MODEL BD-100-1A10 (CL-300)

MODIFICATION – FUEL MANAGEMENT AND QUANTITY GAUGING SYSTEM (FMQGS) – REPLACEMENT AND RELOCATION OF FUEL QUANTITY PROBES NO. 5, AND REPLACEMENT OF FUEL QUANTITY PROBES NO. 8 WITH COMPENSATOR TO CORRECT GAUGING SYSTEM FAULTS

SERVICE BULLETIN

K1000070213 – Kit – Modification and Relocation of Fuel Probe, Wing
(Sheet 1 of 3, Rev. B)

PL K1000070213 – Kit – Modification and Relocation of Fuel Probe, Wing
(Sheet 2 of 3, Rev. B)

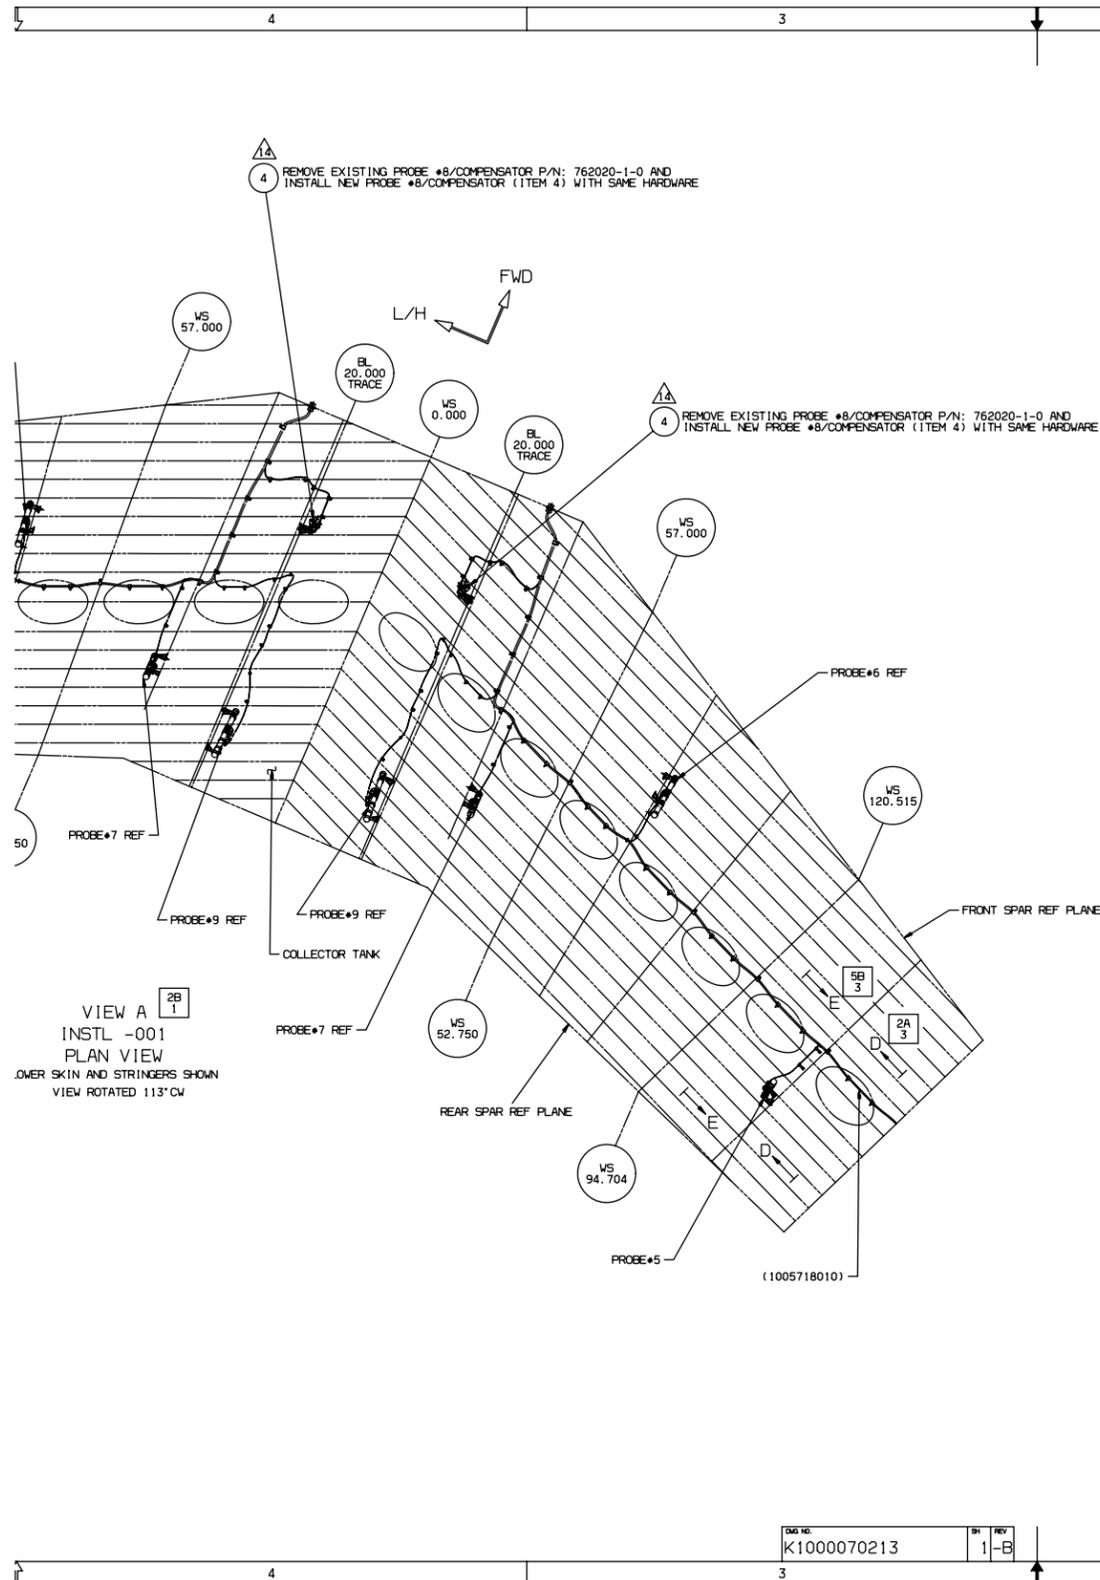
1. SEE THE RELATED T MOD/DCP FOR EFFECTIVITY (REF 100T010278)
2. THIS KIT DRAWING INCORPORATES REQUIREMENTS OF DCP IN100-15030.
3. THE PURPOSE OF THIS MODIFICATION IS TO REPLACE AND RELOCATE PROBE #5 AND TO REPLACE PROBE #8/COMPENSATOR.

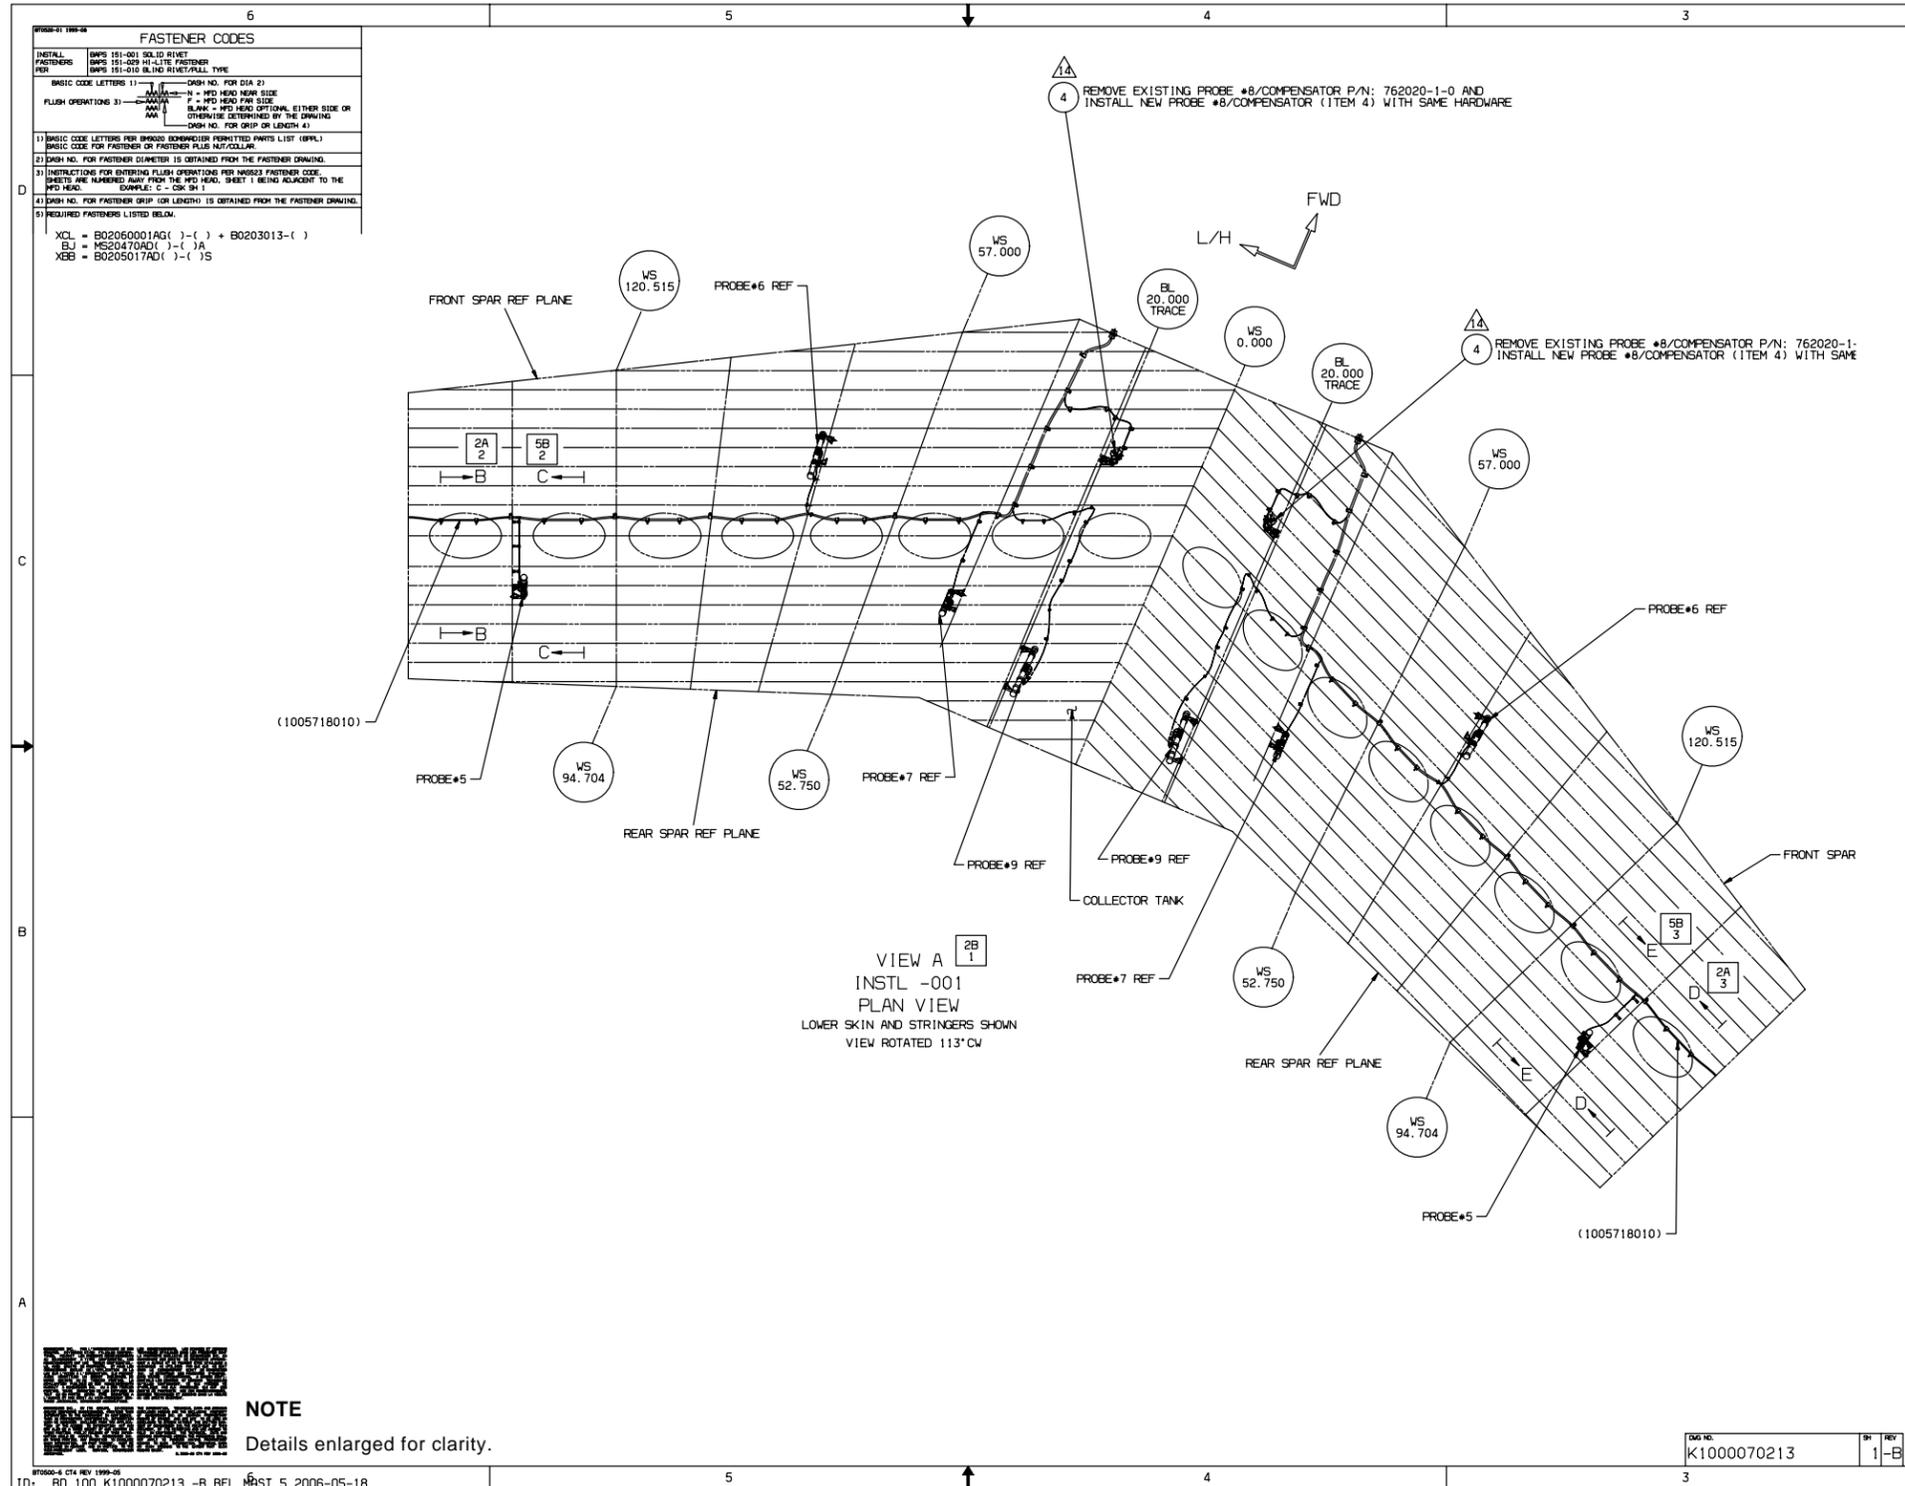
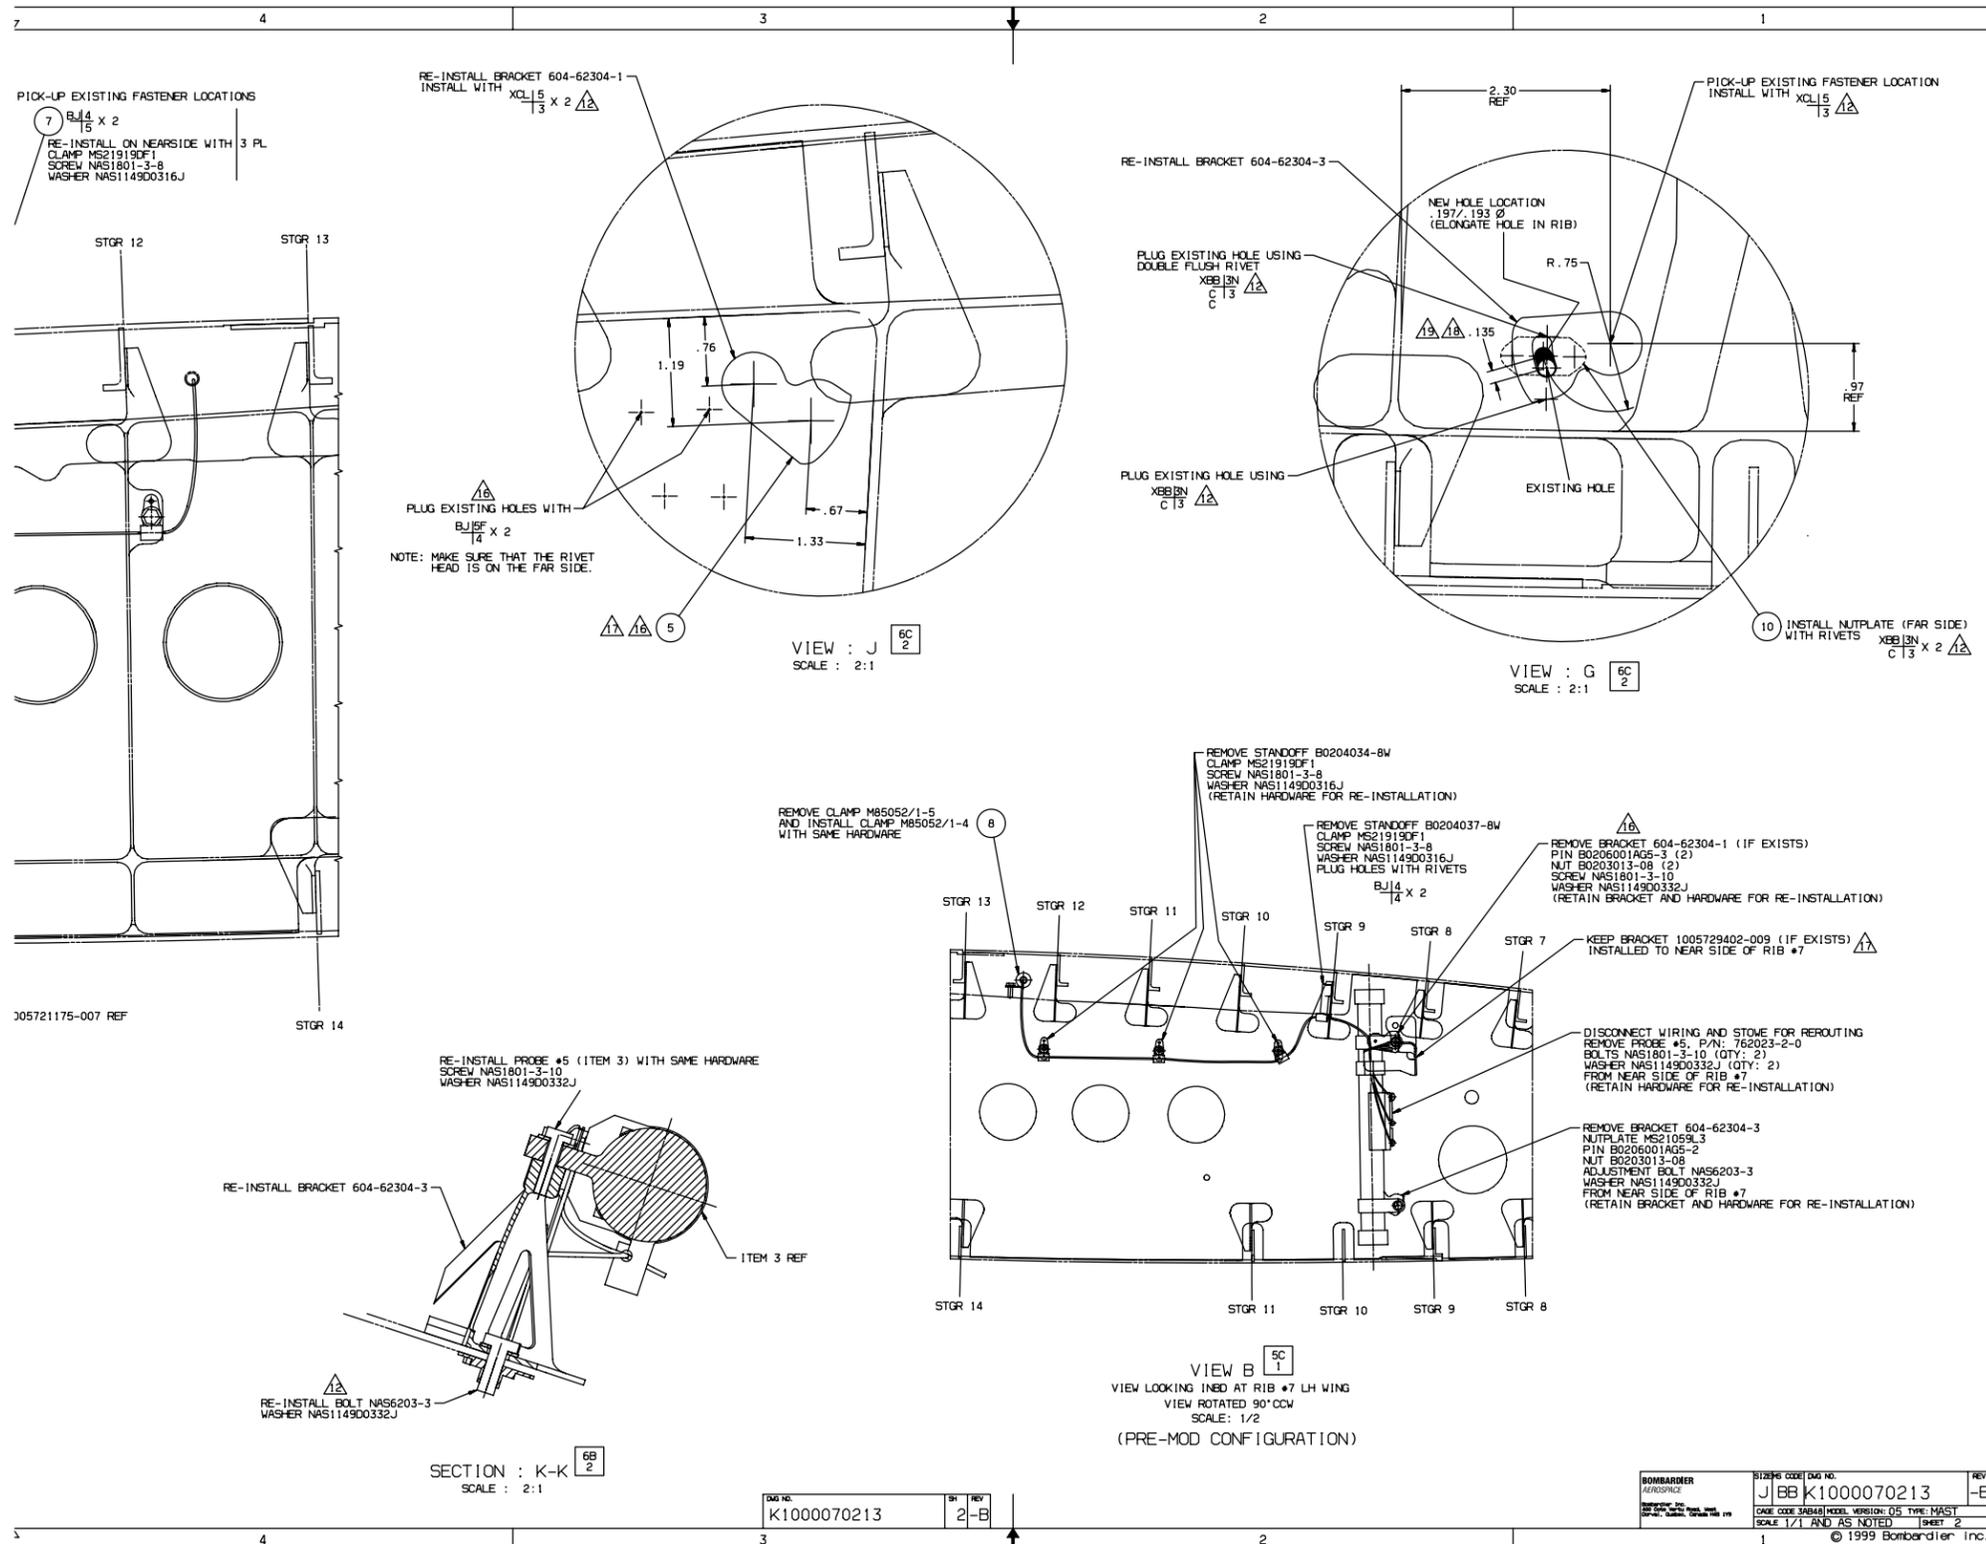
2. REMOVE HARDWARE AND STANDOFFS THAT SUPPORT WIRES AS SHOWN IN VIEWS B & D. STOWE WIRES FOR RE-ROUTING.
3. REMOVE PROBE #5 SUPPORT BRACKETS 604-62304-1/-3 AS SHOWN ON KIT DRAWING.

4. REWORK RIB BY ELONGATING EXISTING HOLE AS SHOWN IN VIEWS F & G.
5. RE-INSTALL BRACKETS 604-62304-1/-3 AS SHOWN IN VIEWS F, G, H & J.
6. RE-INSTALL STANDOFFS PICKING UP EXISTING FASTENER LOCATIONS ON INBD SIDE OF RIB #7 AS SHOWN IN VIEWS C & E. INSTALL STANDOFF ON STGR #10 (RHS) AS SHOWN IN VIEW E & SECTION M-M.

7. RE-ROUTE WIRES AS SHOWN IN VIEWS C & E.
8. INSTALL FUEL QUANTITY PROBE #5 PER BD100 AMM TASK #28-41-13-400-801 AND PROBE #8/COMPENSATOR PER BD100 AMM #TASK 28-41-09-400-801 FOR BOTH LHS AND RHS.

K1000070213 – Kit – Modification and Relocation of Fuel Probe, Wing
(Sheet 2 of 3, Rev. B)

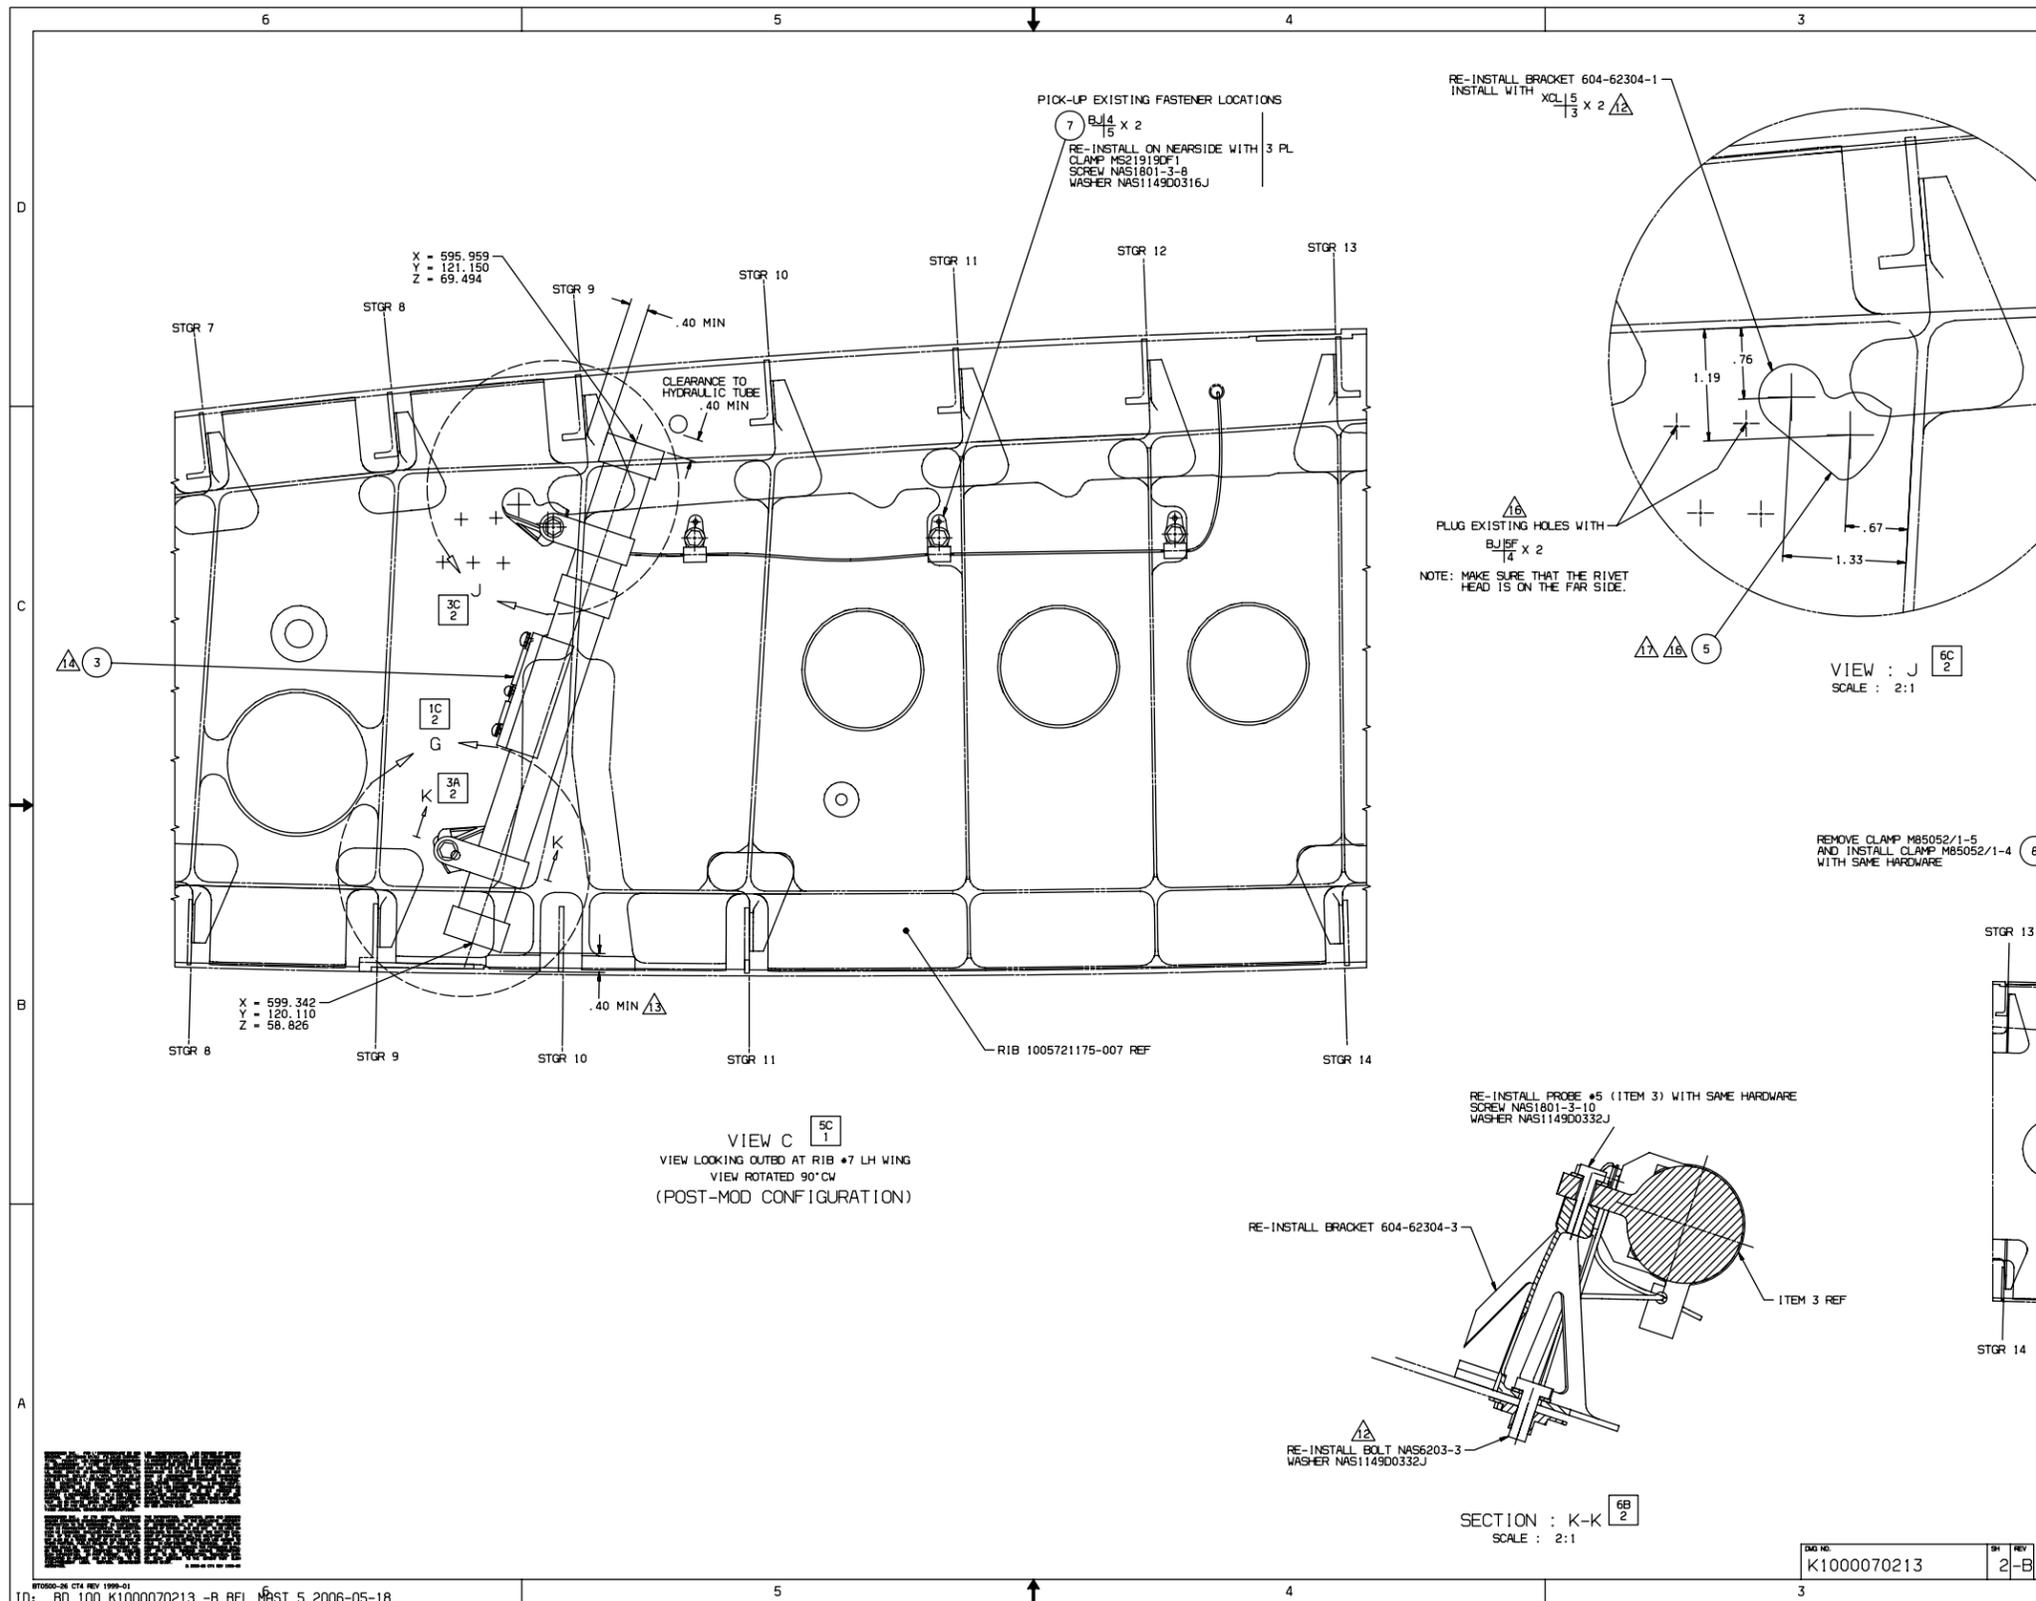
- ⚠ POSITION THE PROBES USING ELONGATION HOLE ON BRACKET 604-62304-3 WITH TEMPORARY TORQUE (LOOSE TORQUE) ON RIVET SO THAT THE CLEARANCE BETWEEN LOWER SKIN AND BOTTOM OF PROBE IS SATISFIED AND FIX BRACKETS 604-62304-3 AND PROBES.

- ⚠ THE COMPONENTS ARE SUPPLIED BY INTERTECHNIQUE.
15. INSTALL WIRE HARNESS PER BAPS 145-003 (WIRING MANUAL CHAPTER 20).
- ⚠ FOR A/C 20017-20088 THAT HAVE BRACKETS 604-62304-1 INSTALLED, REMOVE AND RE-LOCATE AS SHOWN IN VIEW 'H' AND VIEW 'J'.

- ⚠ FOR A/C 20005-20016 THAT HAVE BRACKETS 1005729402-009/-010, KEEP BRACKETS INSTALLED AS IS AND INSTALL NEW BRACKETS 604-62304-1 (ITEM 5) AS SHOWN IN VIEW 'H' AND VIEW 'J'.

- ⚠ ELONGATE THE HOLE AS MUCH AS NECESSARY TO POSITION THE PROBE, BUT STAY WITHIN THE LIMITATIONS THAT FOLLOW. MAKE SURE THAT THE LENGTH OF THE ELONGATION IS NOT MORE THAN 0.135" AND DOES NOT CUT THROUGH THE NEARBY RIVET HEAD.
